## ORIGINATION FORM

Proposed Revisions to a Standard Plans Index  
(Please provide all information — Incomplete forms will be returned)

Index Number: 102-606  
Sheet Number (s): 1 of 1  
Index Title: Two-Lane Roadway, Lane Closure Using  
Temporary Traffic Signals

| LAST REVISION | DESCRIPTION: |  | FY 2021-22<br>STANDARD PLANS | TWO-LANE ROADWAY, LANE CLOSURE USING<br>TEMPORARY TRAFFIC SIGNALS | INDEX<br>102-606 | SHEET<br>1 of 1 |

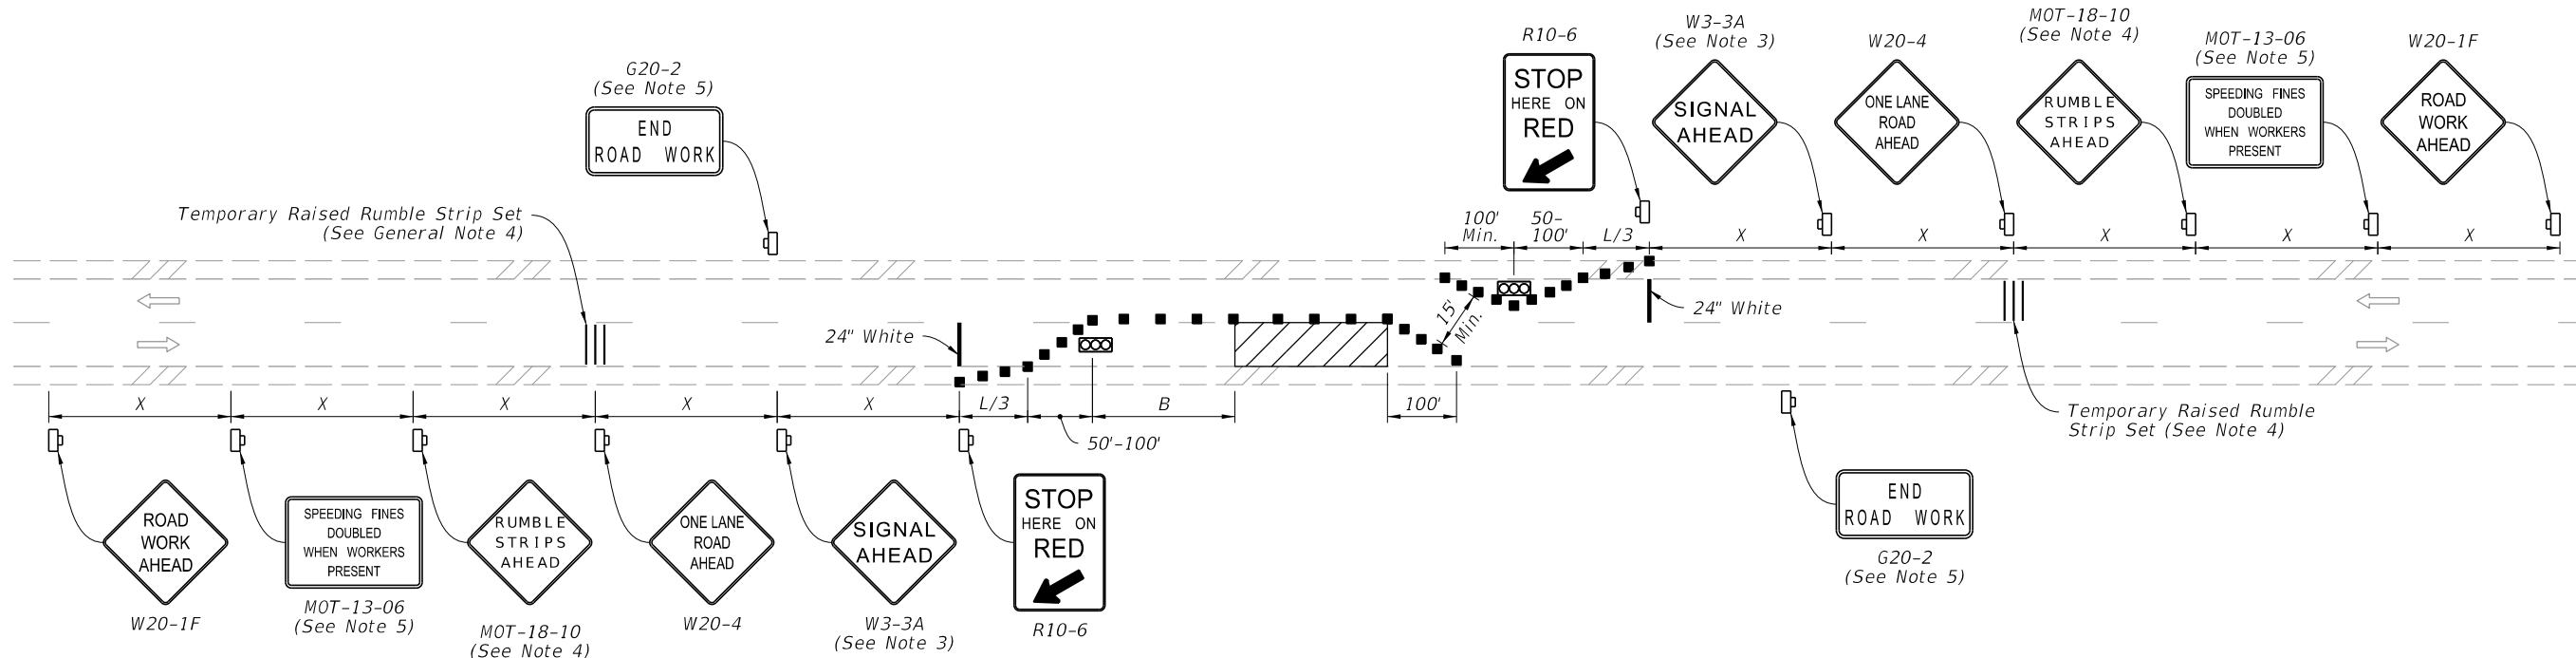
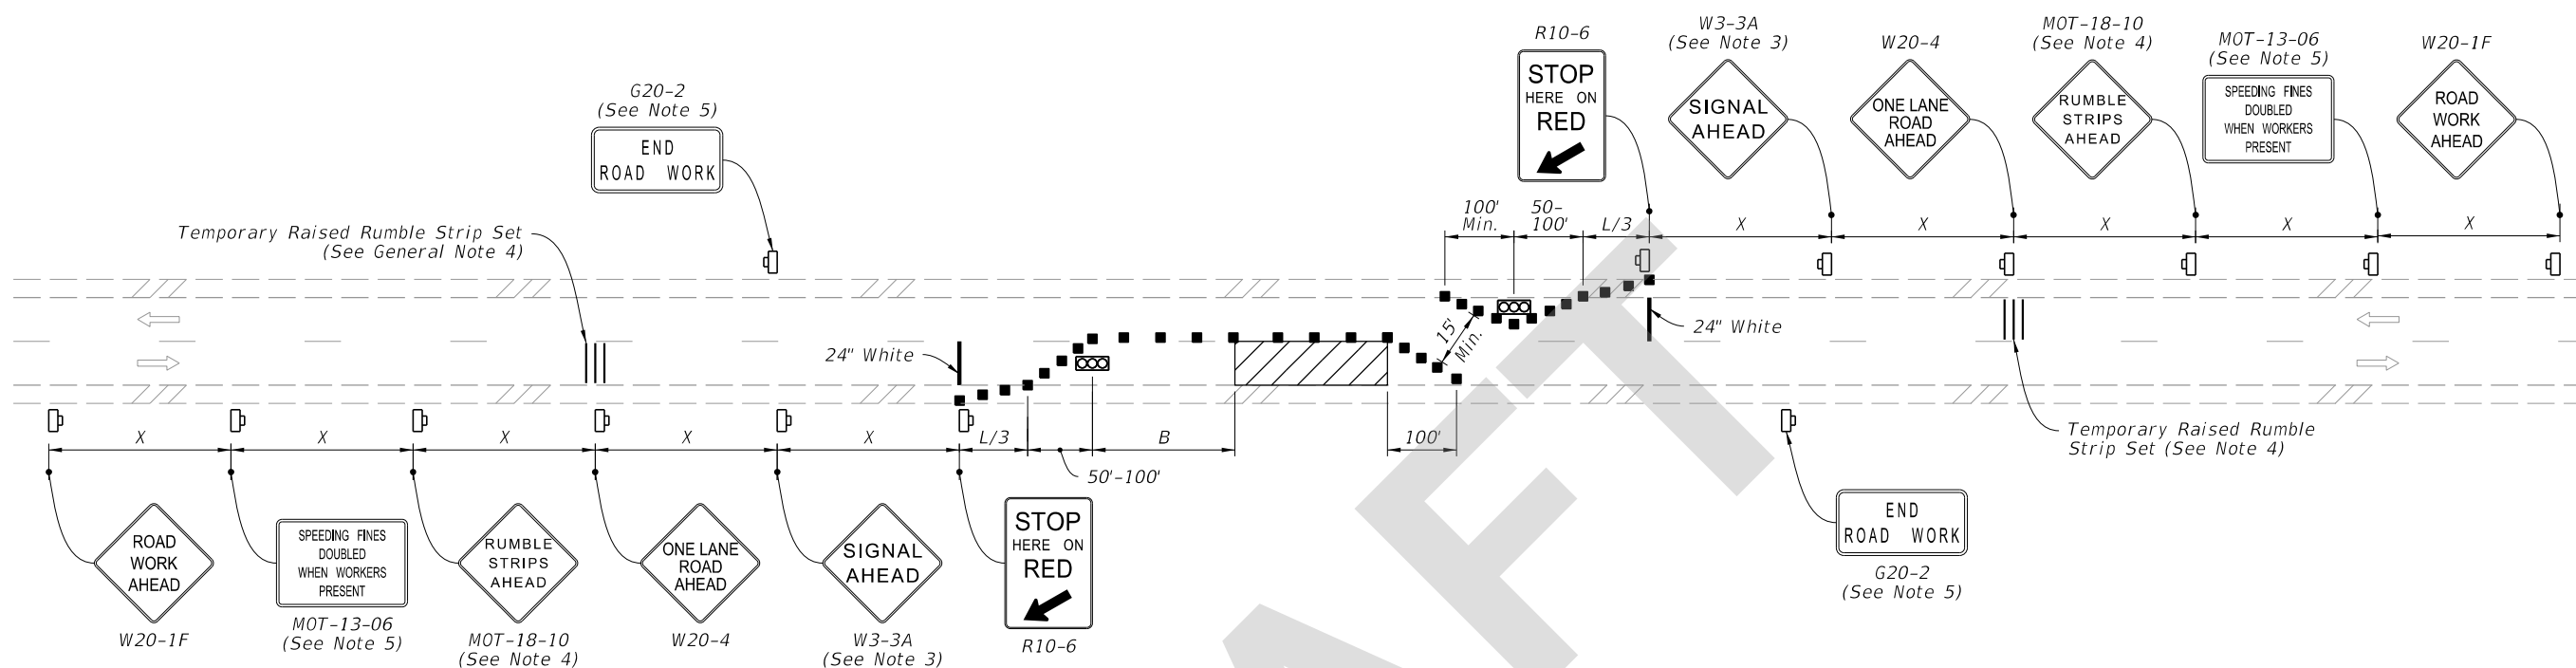
Sheet 1: Changed Note 5 - "work zone" to "work operation";  
Deleted Note 8;  
Moved the SIDE ROAD INTERSECTION THE WORK ZONE detail to Index 102-600 - Sheet 7.

The duration provisions of the index are intended to apply to the length time needed to perform the specific temporary traffic control work "operation" shown, which is independent of the duration of an overall construction project. The term "Work Zone" is being replaced with "Work Operation" to clarify the intent.

**CHANGED TO: operation**

**DELETED: Note 8.**

5. The "Speeding Fines Doubled When Workers Present" signs (MOT-13-06) and "End Road Work" signs (G20-2), along with associated work zone sign distances, may be omitted when the work zone will be in place for 24 hours or less.

8. ~~If the work encroaches on a marked bicycle lane or rideable shoulder, close the lane or shoulder in accordance with the Plans.~~

4. Use temporary raised rumble strips in accordance with Index 102-603.
5. The "Speeding Fines Doubled When Workers Present" signs (MOT-13-06) and "End Road Work" signs (G20-2), along with associated work zone sign distances, may be omitted when the work operation will be in place for 24 hours or less.
6. For the maximum distance between temporary traffic signals, do not exceed the distance at which the temporary traffic signals can safely communicate. When the distance temporary traffic signals is greater than 0.25 miles, use a combination of a pilot vehicle and manually-controlled temporary traffic signals.
7. Monitor temporary traffic signals by having one or more workers present during operation. In the event of a temporary traffic signal failure, use flaggers to control traffic.
